AGENDA PLANNING AND ZONING COMMISSION WORK SESSION City Hall, 385 South Goliad, Rockwall, Texas Council Chambers January 28, 2020 6:00 P.M.

PLANNING AND ZONING COMMISSION CASE MEMO

TO:	Planning and Zoning Commission
DATE:	January 28, 2020
APPLICANT:	Michael Hunter; Rockwall Housing Development Corporation
CASE NUMBER:	P2020-002; Lot 1, Block A, RHDC Addition

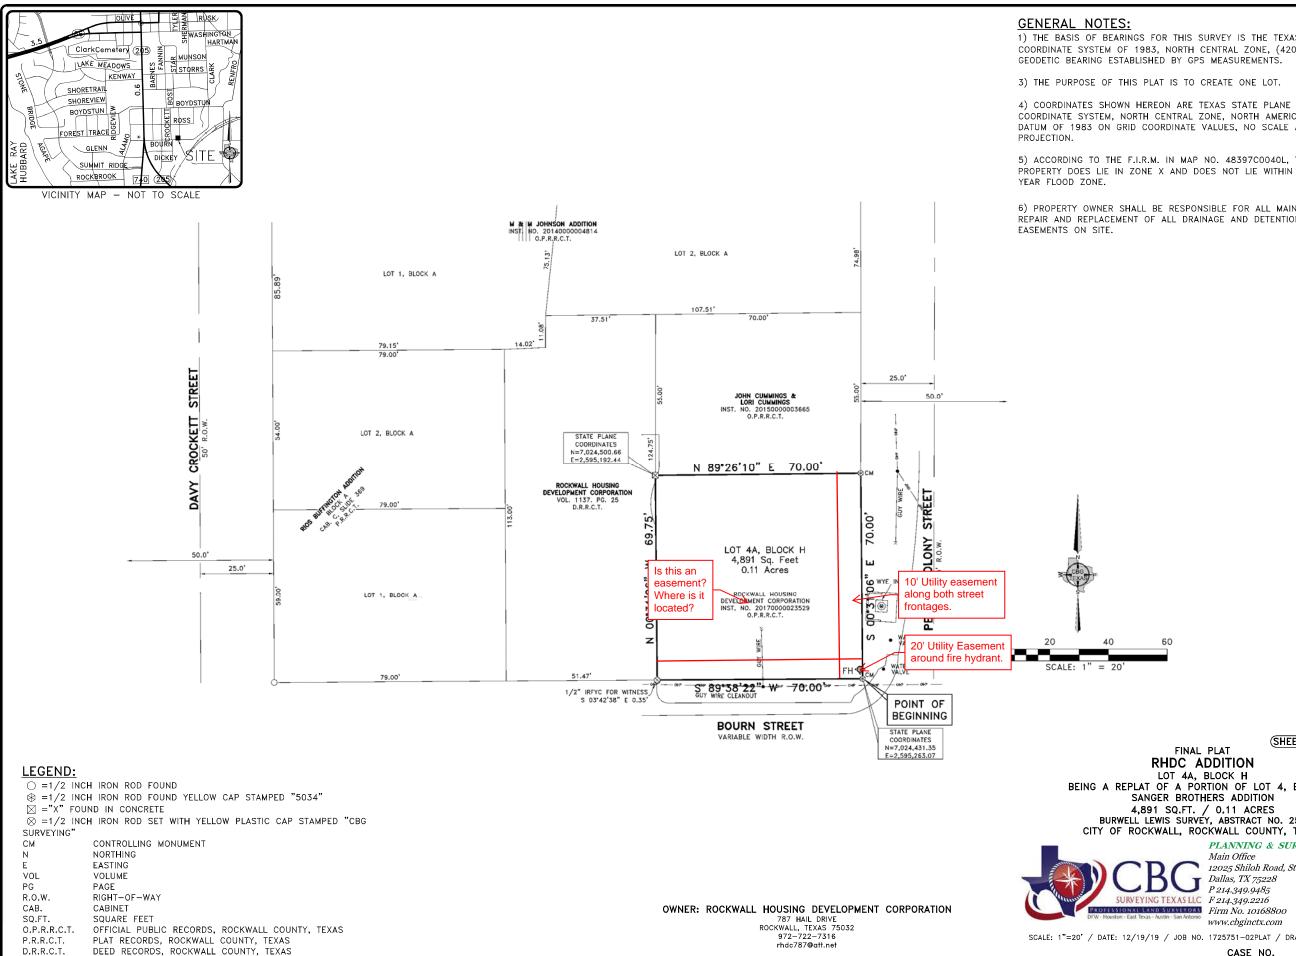
1) Please show and label 15-foot front setback adjacent to Peters Colony.

2) Please show the full width of ROW and label centerline

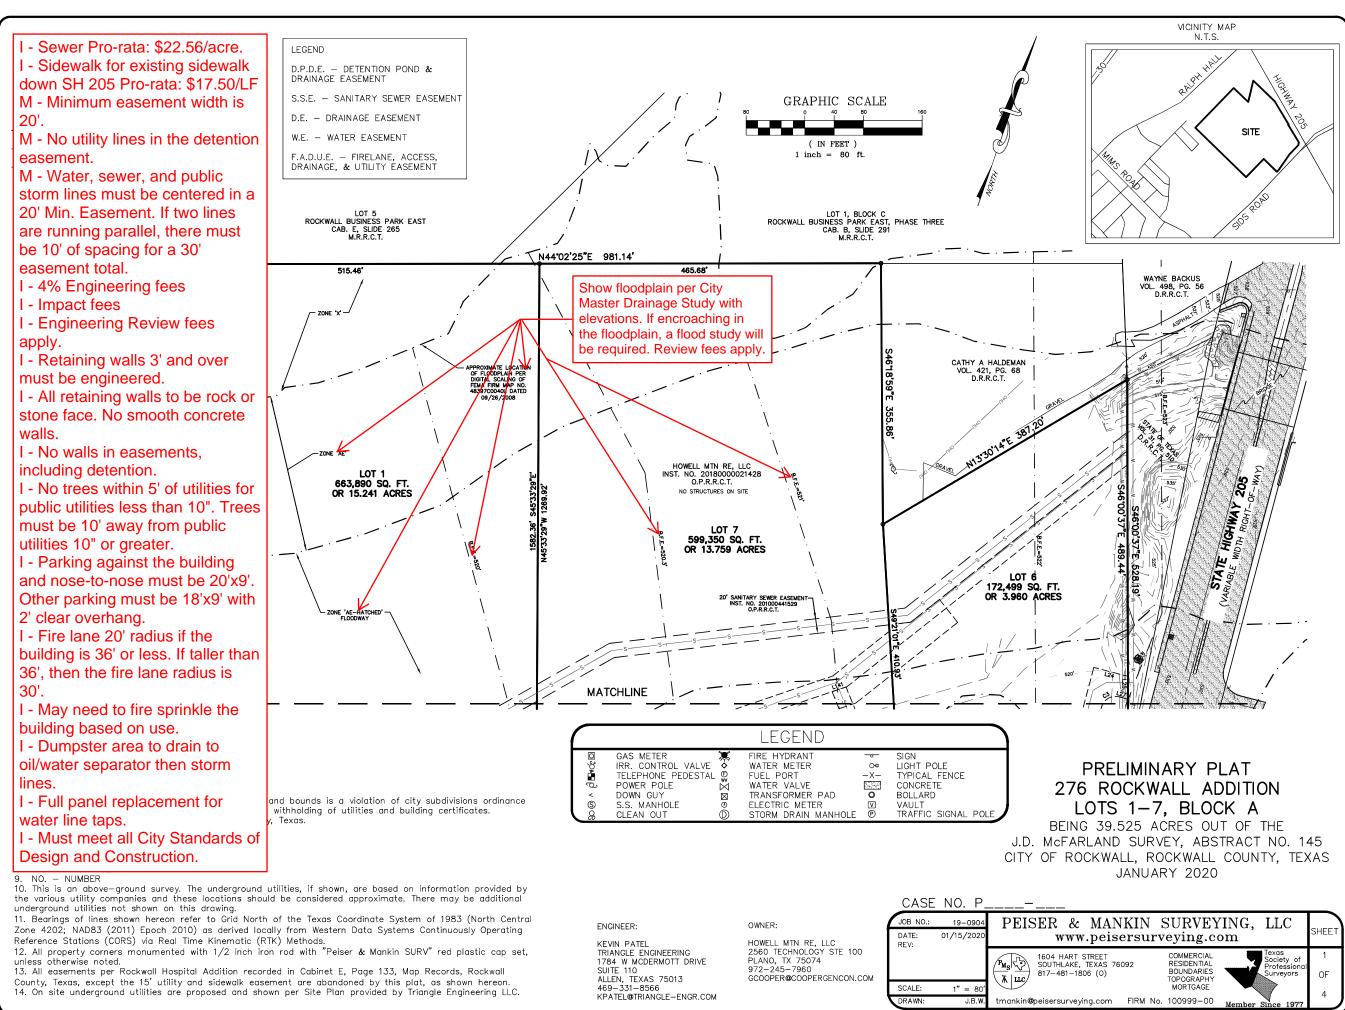
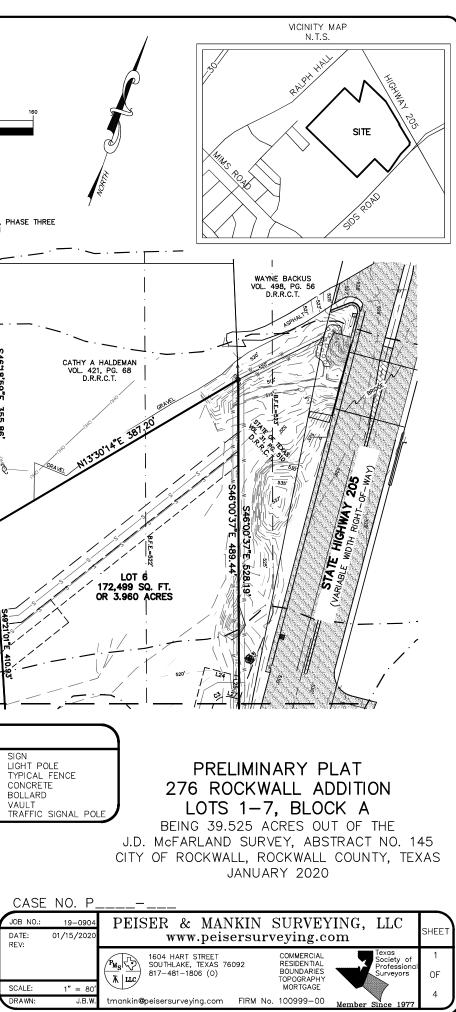
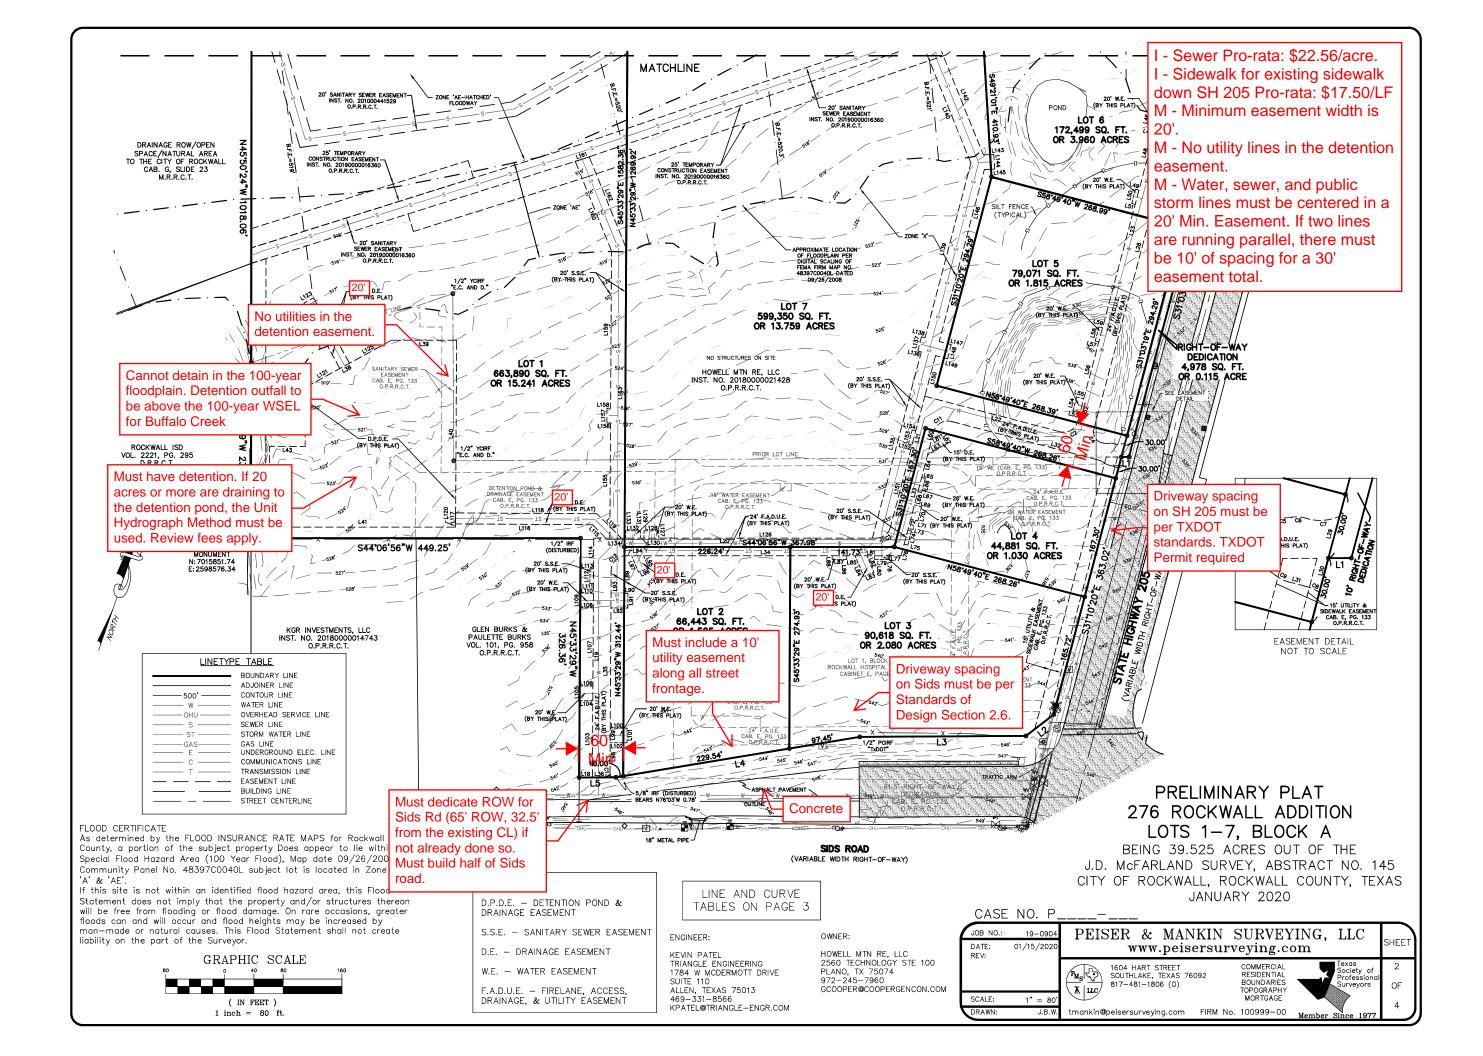
M.5 Please make the following clarifications on the replat to ensure staff can properly review this project and convey all of the required elements to the Cit's boards and commissions:

1) Please provide prelim drainage plan and prelim storm and sanitary sewer plans

- 2) Please show and label front setbacks
- 3) Please show centerline of Sids Road.
- 4) Since this is a prelim plat, please remove dedication language.

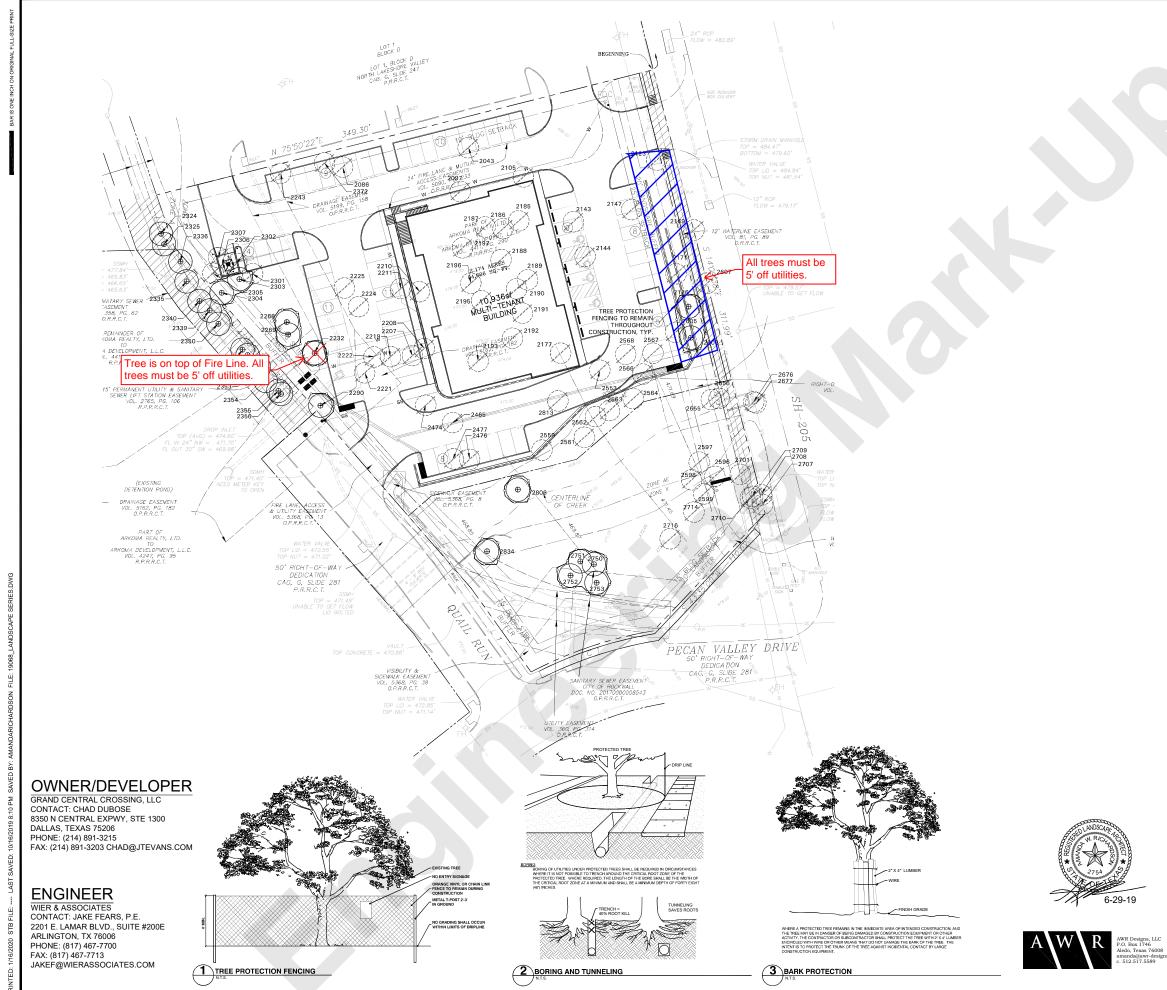
M.5 Provide an updated treescape plan that represent a mitigation balance due of1,155-caliper inches.

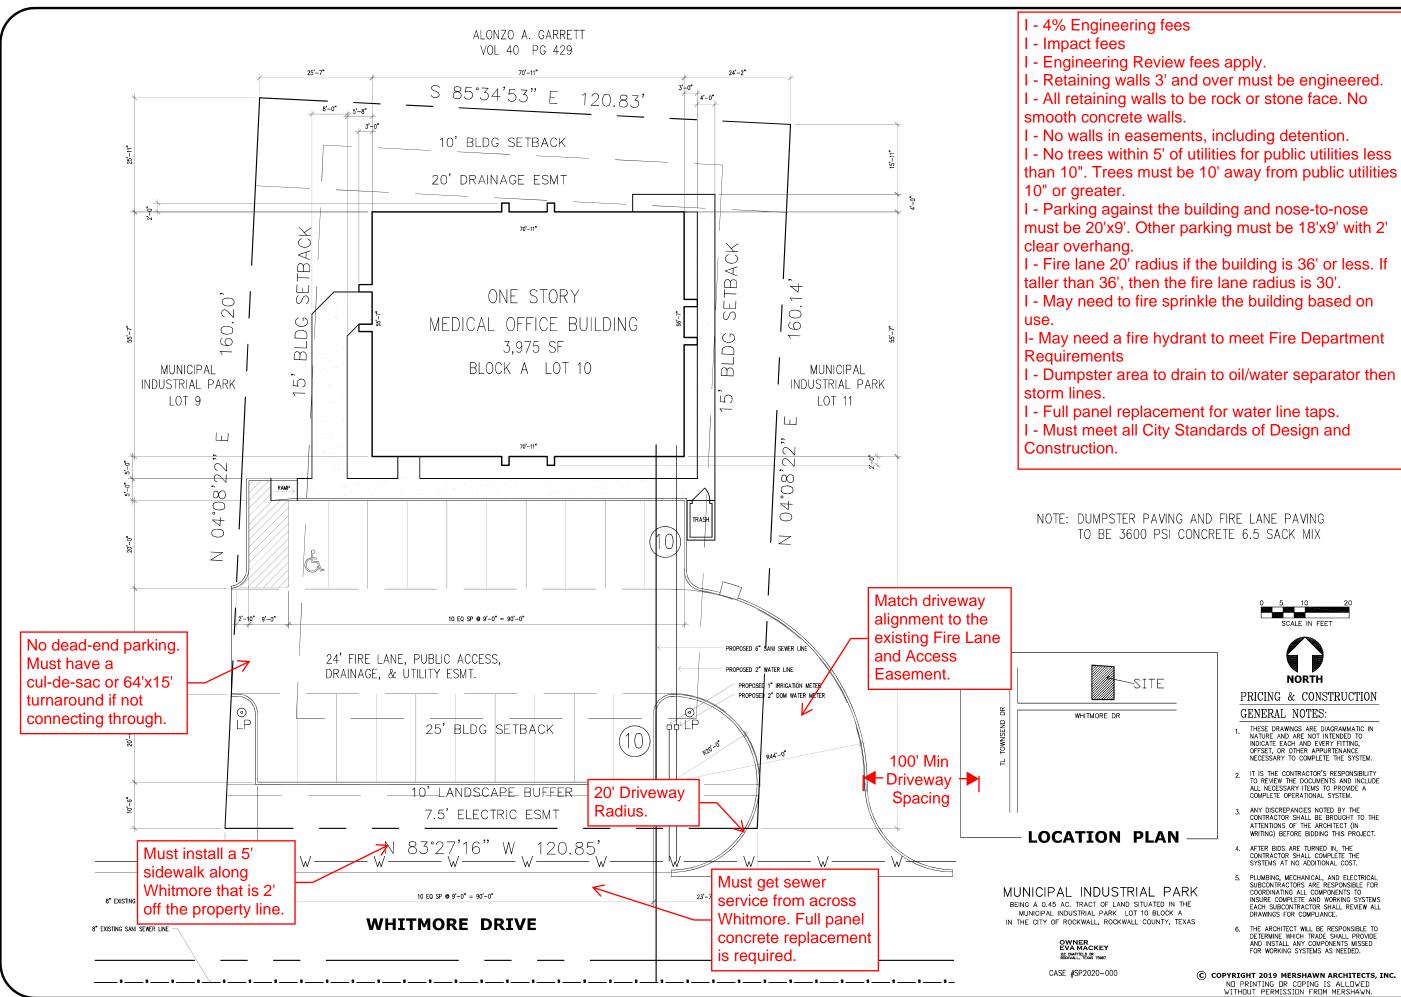
- 9) Please label property line.
